PCN No. 0114

PCN Type Product Replacing

Product 711-20339 Relay Holder

Date August 26, 2014

Typical Standard Relay

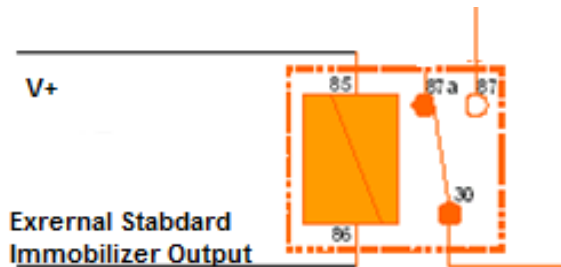
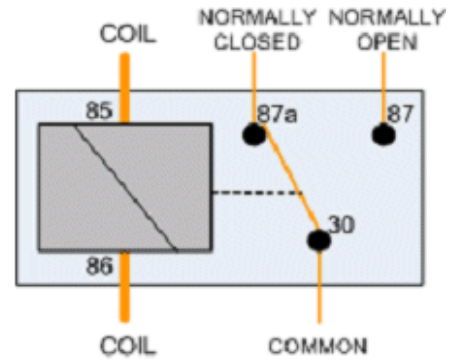
A protective element has been added to the yellow wire of the Relay Holder, connected to pin 85 of the relay, in order to support Automotive Directive 2004/104/EC (E-Mark). This arrangement enforces pin 85 of the relay is connected to power and pin 86 to the unit output.

The change and the required connection are presented in the following picture and drawings.

COLOR	Pin Num
Black	30
Blue	87
Green	86
Red	87a
Yellow	85
